Product Change Notification / RMES-15KLMX168

CCB 4502 Initial Notice: Qualification of NSEB as a new assembly site for ATTINY43x, ATTINYx4x, ATTINYx313x, ATTINY84x, ATTINY1634x, ATTINY44x, ATTINY13x, ATTINY85x, AT73C508, ATTINY45x, ATTINY25x and QT14C10 device families available in 20L WQFN (4X4X0.8mm) package.

CCB 4502
Pre and Post Change Summary
PCN #: RMES-15KLMX168

ASKR

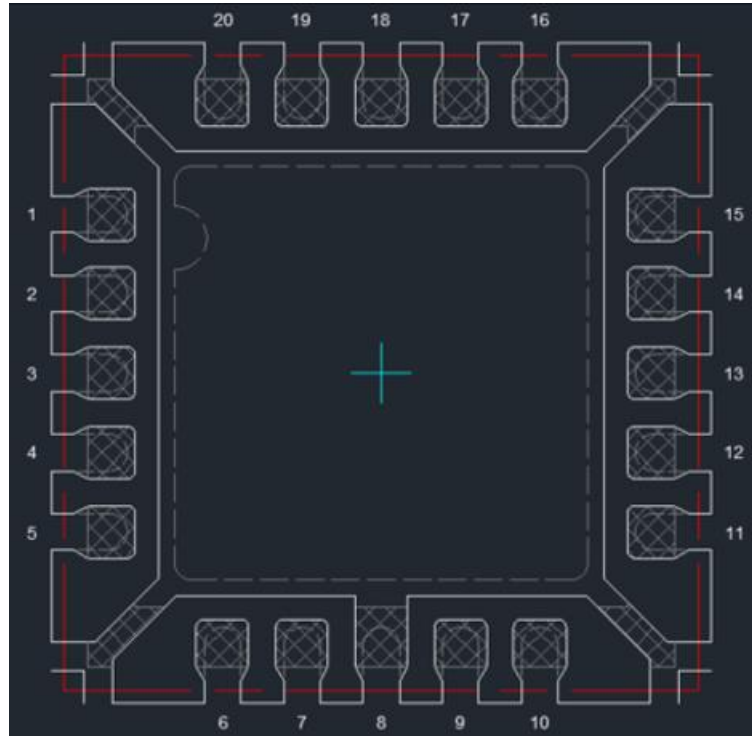
LEAD FRAME COMPARISON

Lead Lock

No

NSEB

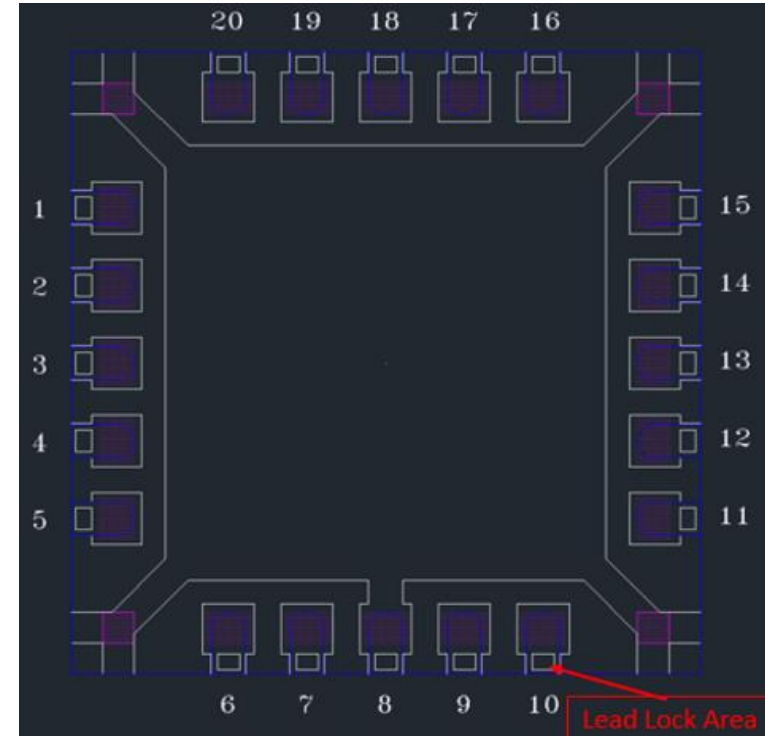
Lead Lock

Yes
